Review of Expert Panel and Beca Report on PGC Building

William T. Holmes
Structural Engineer
San Francisco

Pyne Gould Corporation Building

Structural plan of Ground and Level 1

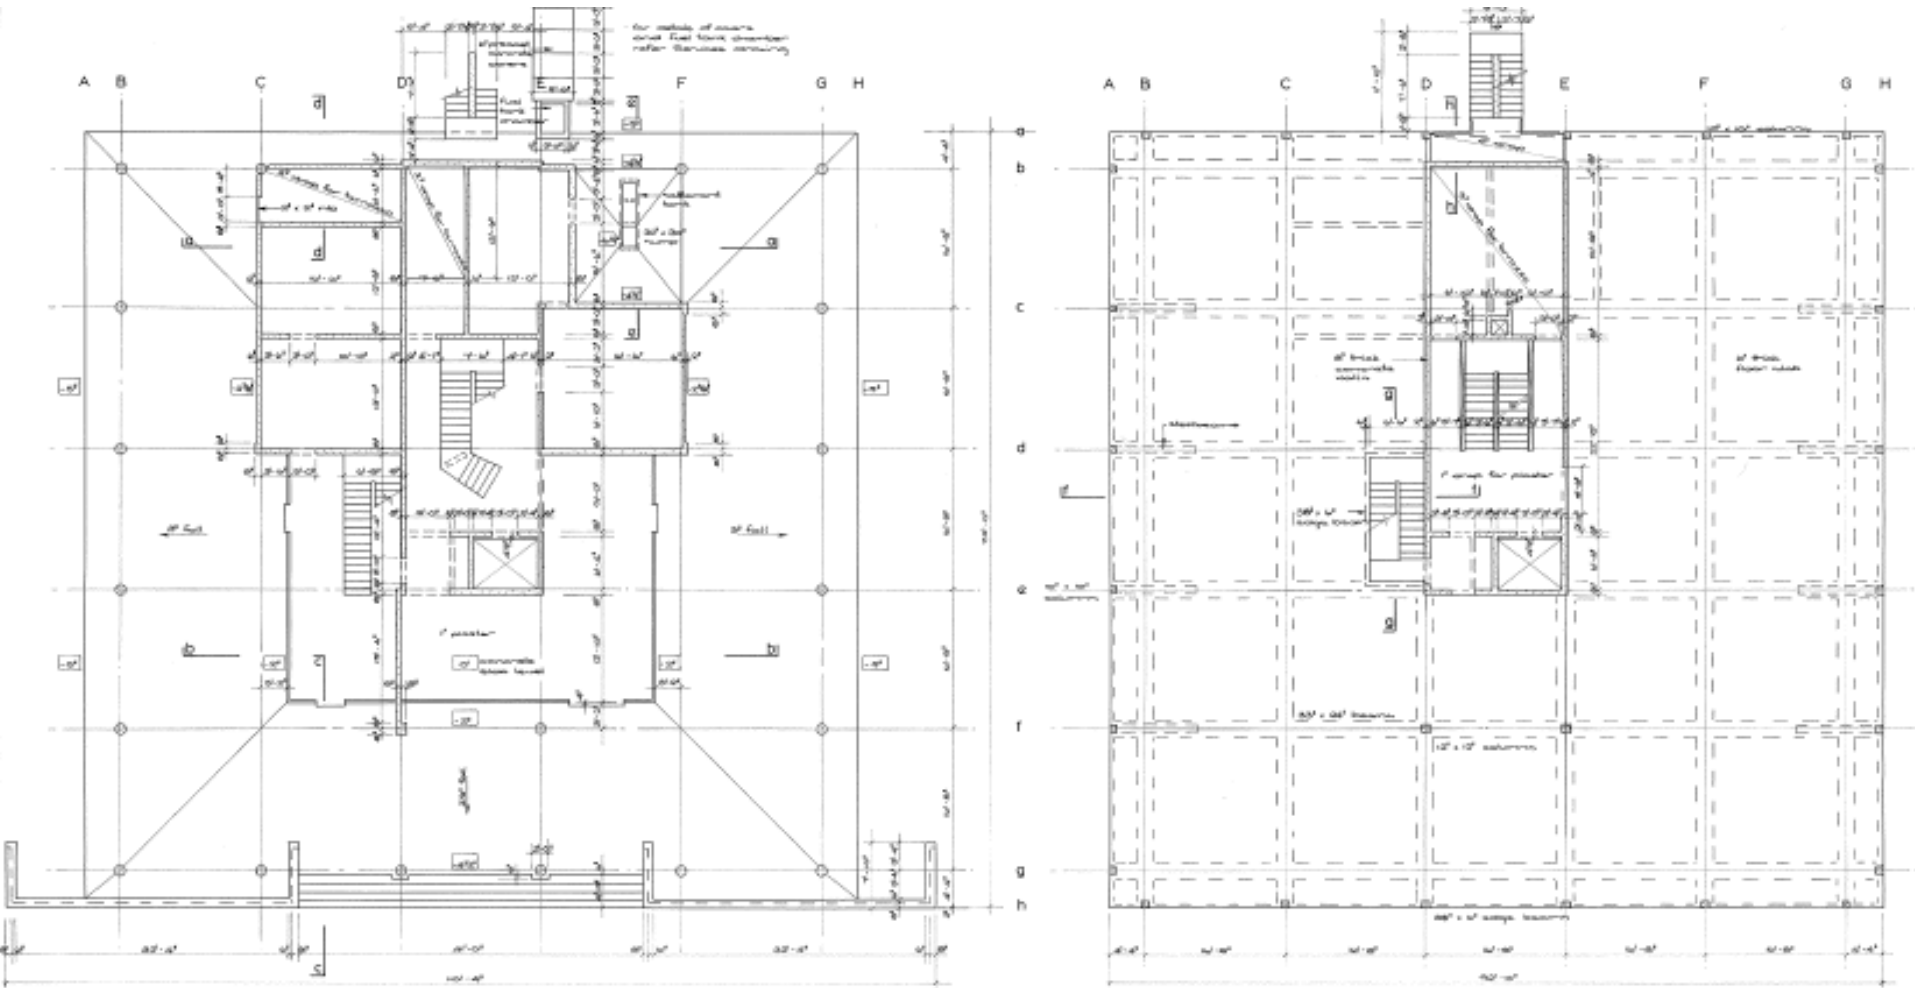
- All agree that building collapsed due to failure of the central tower at floor 1-2
 - Failure caused large movement of Level 2 downward and to the east (about 3 m)

Level 1-2 had many seismic deficiencies

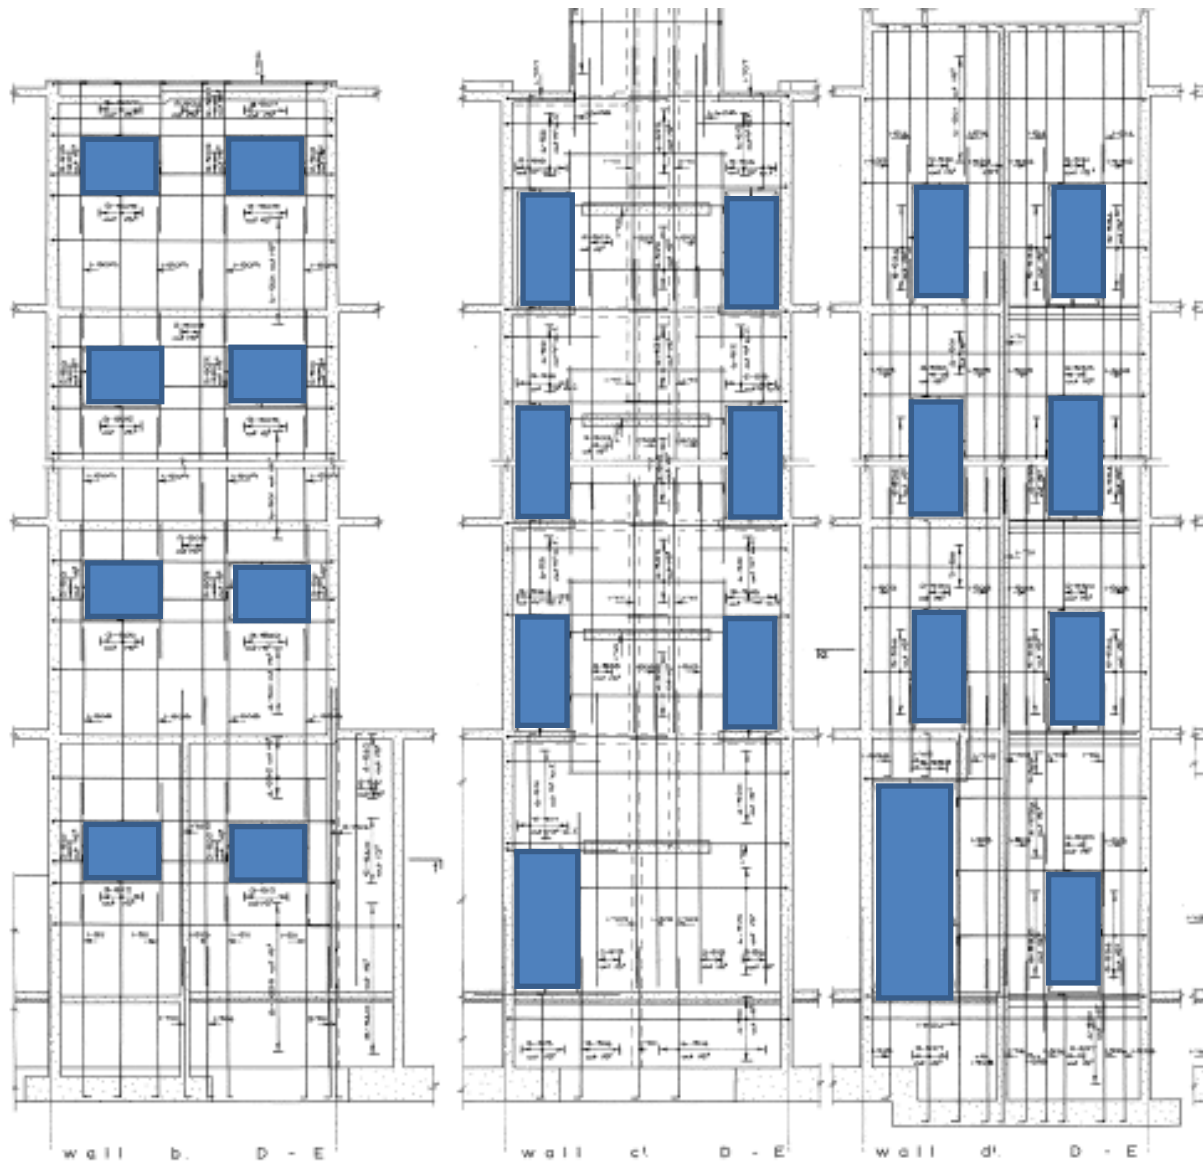
- Light central reinforcement.
 - Weak in global flexure (overturning)
 - Weak in EW shear (many openings, low R/F ratio, small trim bars. Piers in North Wall appear to be “shear critical”)

Can these walls provide sufficient coupling of east and west wall for the tower to act as a unit?

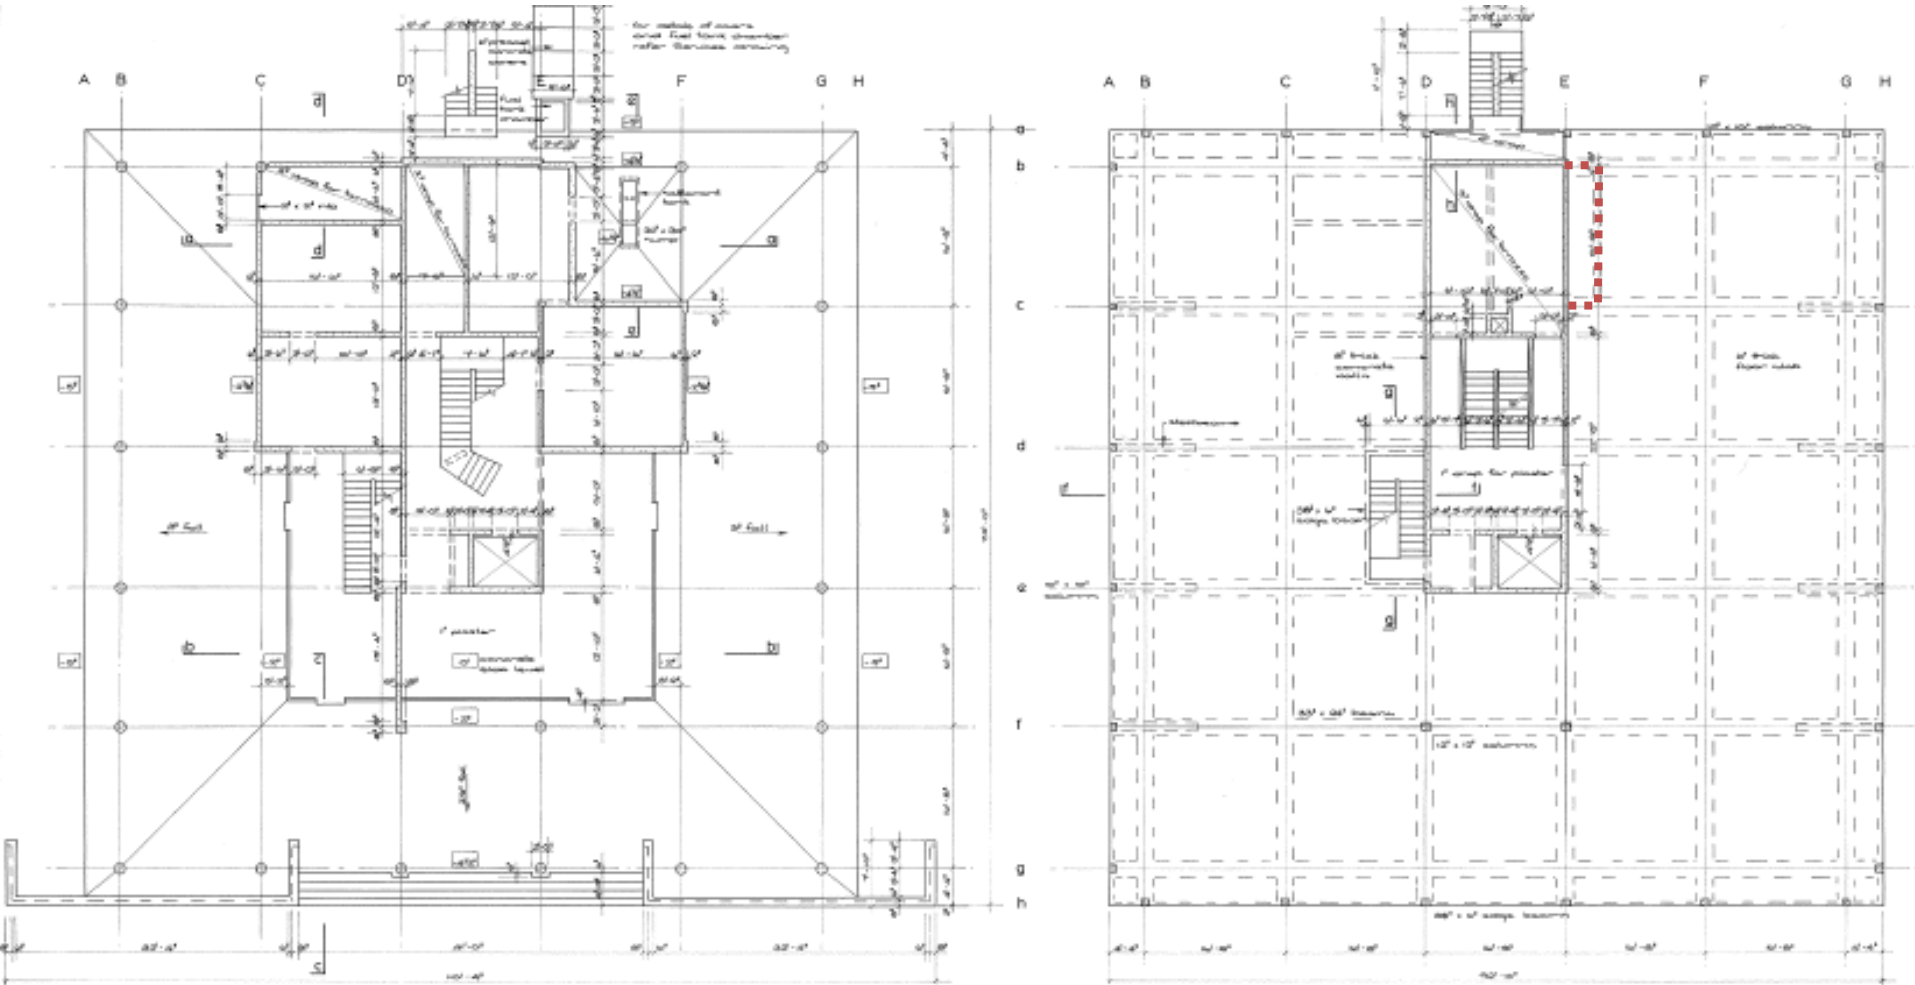
If so, would the south wall fail in shear prior to a flexural tower failure?

Our calculations indicate these various failure modes have reasonably close yield strengths.— Too close to call.

Structural plan of Ground and Level 1

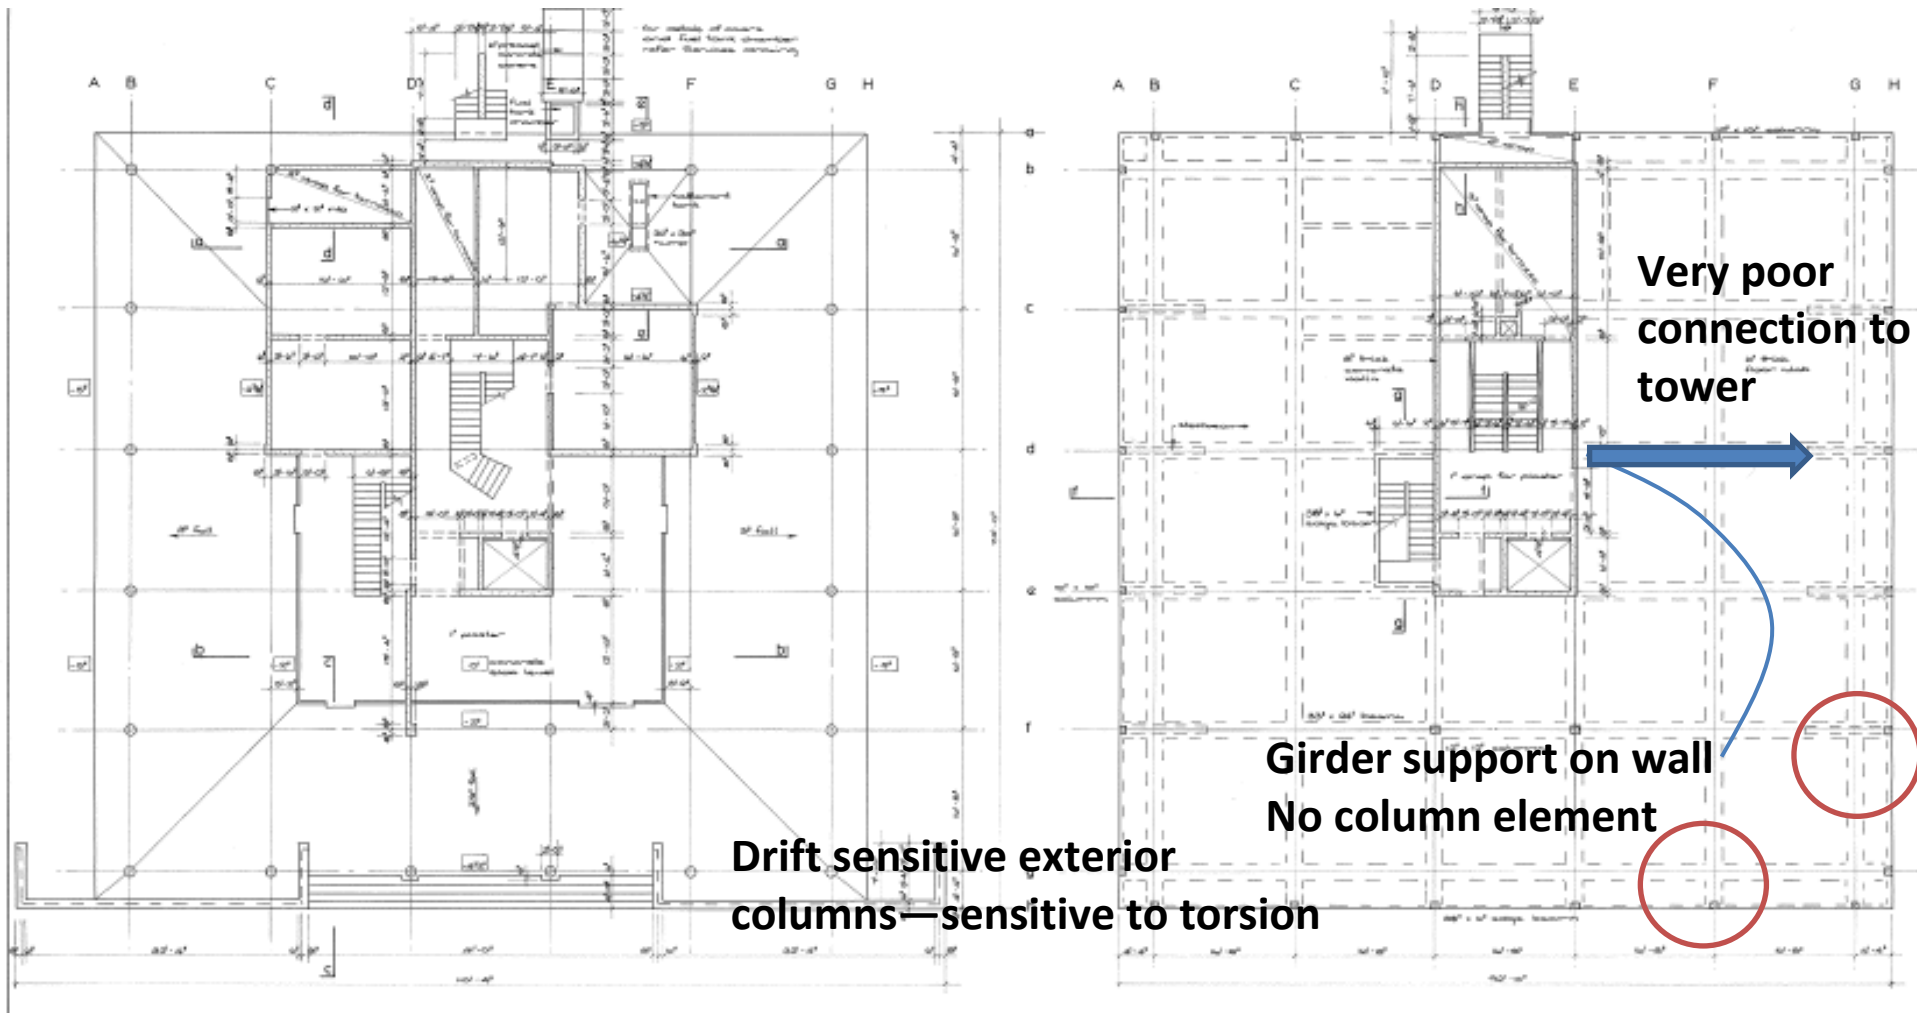
Drift sensitive exterior columns—sensitive to torsion

Very poor connection to tower

Girder support on wall
No column element
